TYPICAL PAVEMENT MARKINGS AT ENTRANCE RAMPS

LAST REVISION 11/01/23	REVISION DESCRIPTION		FY 2025-26 STANDARD PLANS	INTERCHANGE MARKINGS	INDEX 711-003	SHEET 2 of 8
---------------------------	----------------------	--	------------------------------	----------------------	------------------	-----------------

TWO-LANE PARALLEL-TYPE ENTRANCE WITH ADDED LANE
(Single-Lane Parallel-Type Entrance Without Added Lane Similar, See Note 3)

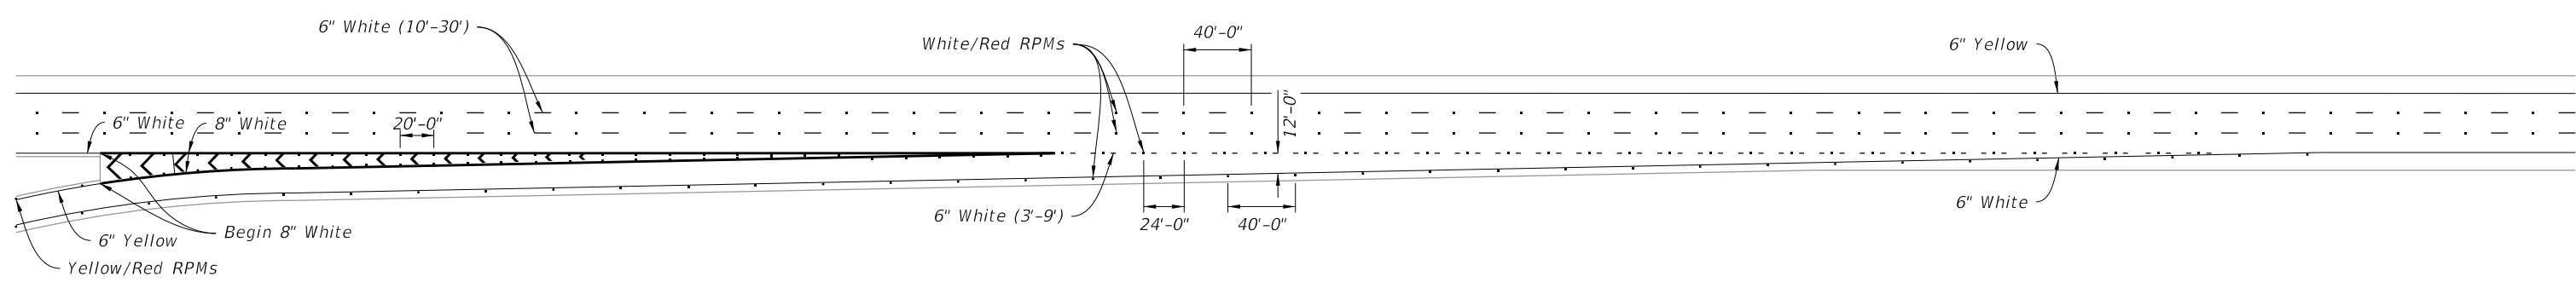
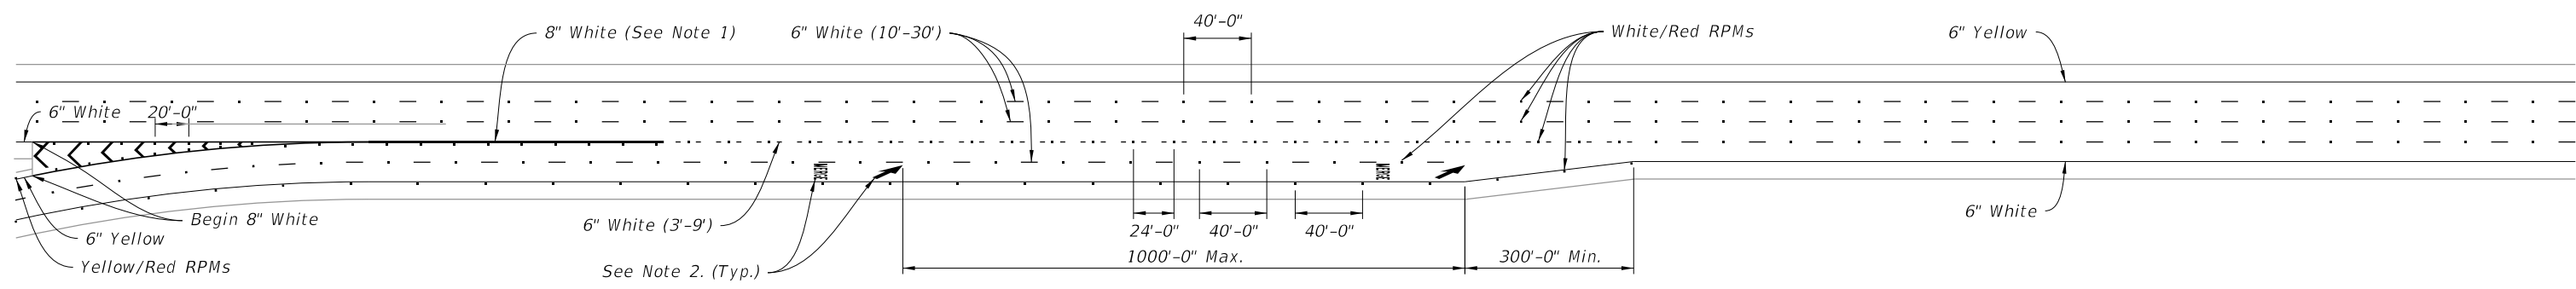
Revised Note to clarify use of dotted interchange line.

1. Extend this 8" white Pavement Marker one-fourth the length of the acceleration lane from the gore markings.
2. See Index 711-001 for pavement message dimensions and details.
3. Discontinue the 6" White (3'-9") Dotted Interchange Line where the merging taper begins for a Single-Lane Parallel-Type Entrance Without Added Lane. Merge Pavement Message and Arrow only used for Two-Lane Entrances.
